Comment on the Draft NEPA Environmental Impact Statement for the Millennium Bulk Terminals — Longview

by Michael Riordan, Ph.D.

Fig. 1. Coal dust on deck of a bulk carrier being loaded at the Westshore Terminals in Delta, British Columbia (photo credit: Paul K. Anderson).

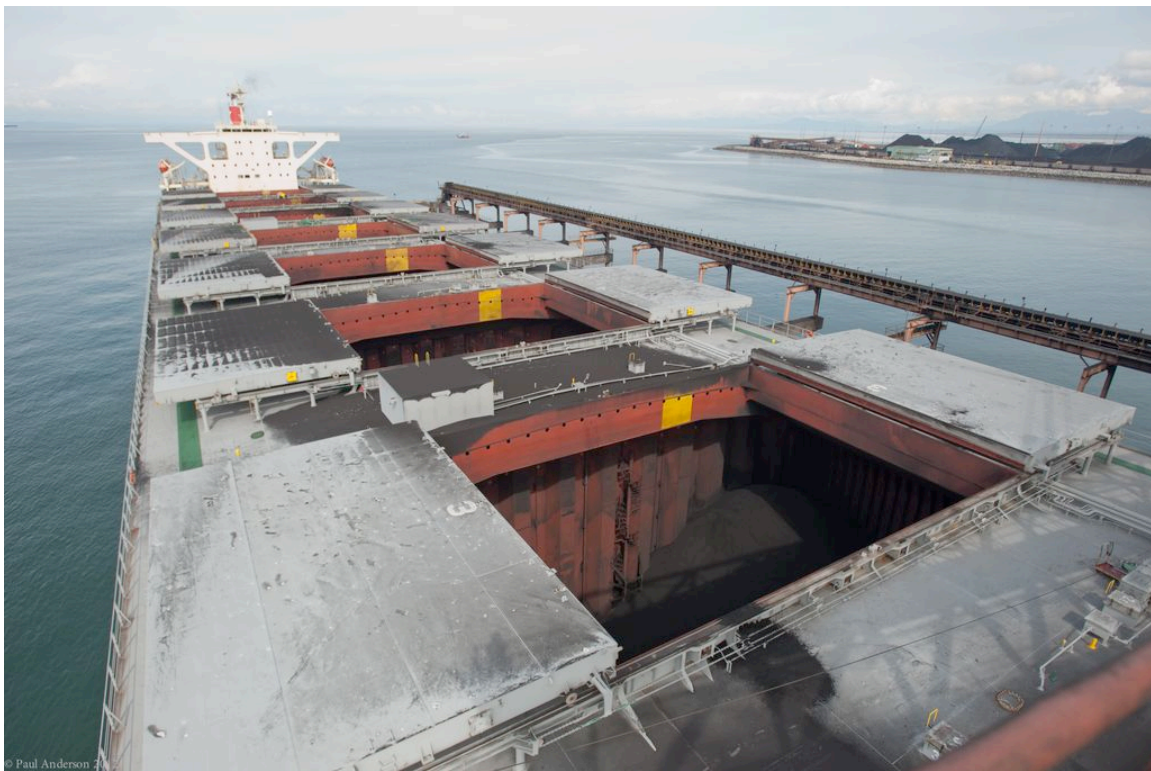
Actual experience from other coal terminals has shown that these losses at the piers are the dominant contribution to the coal dust that enters adjacent waters. A close parallel to the MBTL ship-loading process can be found at the Westshore Terminals in Delta, British Columbia, at which the photograph in Fig. 1 was taken. Note especially

that the ship holds were filled to less than 50 percent at the time this photo was taken and that there were already large quantities of coal dust on the deck — and presumably that had fallen into the adjacent waters of the Salish Sea. If we assume that 100,000 tons had been loaded by this time, the URS Corporation approach would yield a mere 4 pounds of coal dust released, using the 95 percent efficiency factor. Clearly, this is ridiculously low. This kind of loss can only get worse proportionally as the holds are filled to the brim and the dust kicked up is exposed more directly to the winds passing over the ship. Another important feature to note is the bulk coal dropped onto the deck in the foreground, which often occurs due to operator error as the ship-loading chute passes repeatedly from one hold to the next during loading. The coal that has thus accumulated on the decks of these bulk carriers can then be readily blown into the waters below by ambient winds. Such a process was observed by the person who shot this photograph; it has also been reported and photographed by Lummi fishermen and women working near this coal terminal.¹⁶

Fig. 2. Coal dust accumulations on the Salish Sea floor adjacent to the Westshore Terminals during a 22-year period from 1977 to 1999 (Johnson and Bustin, ref. 17).

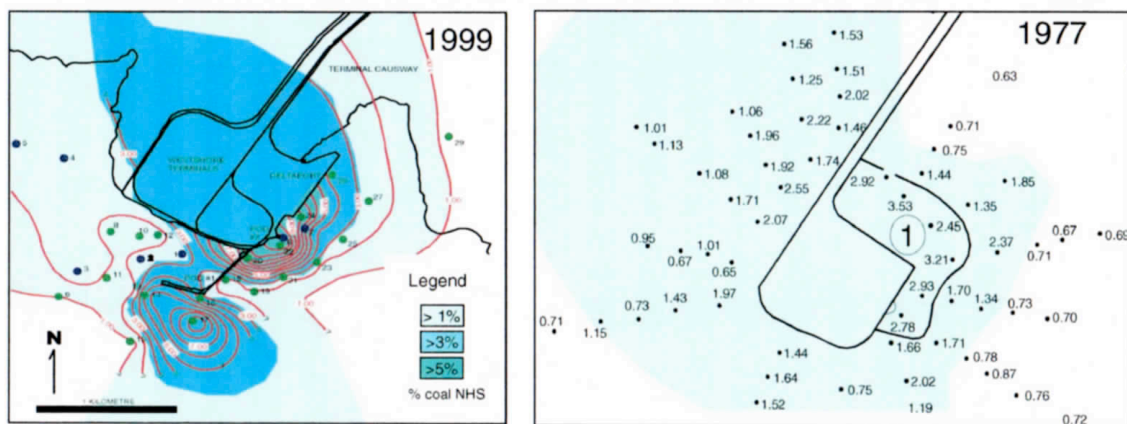
All told, including coal dust losses from ship loading (plus that due to operator error), from uncovered conveyors leading to the piers, and from the remaining terminal operations, one can readily estimate that between 10 and 15 tons of coal annually will fall into the Columbia River near the MBTL piers. An idea of the cumulative impacts of these losses can be obtained from an analysis of the sea floor at Westshore Terminals (Fig. 2).¹⁷

In this instance, the quantity of coal loaded annually was substantially less than half the amount that would be loaded at the MBTL piers, about 22 million tons/year or less, and the loading process was similar, with uncovered conveyors extending over the water and loading chutes that extended well down into the ship holds. Note that coal accumulations of 5 percent or greater were measured just southeast, or downwind in the summer, from the two loading piers at Westshore Terminals; closer to the piers, coal particles exceeded 10 percent of the material sampled from the sea floor. Examination of the coal in these areas revealed large-size particles greater than 100 micrometers in diameter, which most likely occurred from spillage due to operator error, as they are too large to have come from wind-driven fugitive-dust processes.¹⁸ This observation demonstrates that estimates limited to wind-driven coal dust, as done in the SEPA and NEPA environmental impact statements for MBTL, will *dramatically underestimate* the amount of coal particles that reach the floor of the Columbia River. Coal losses in loading due to operator error are extremely important and cannot be ignored — as they were in those studies.

²⁴ A good comparison with the Westshore example can be found in Fig. 2, where one will note a large blue dust plume extending NW of the terminal, obviously due to the strong SE winds that occur every winter.
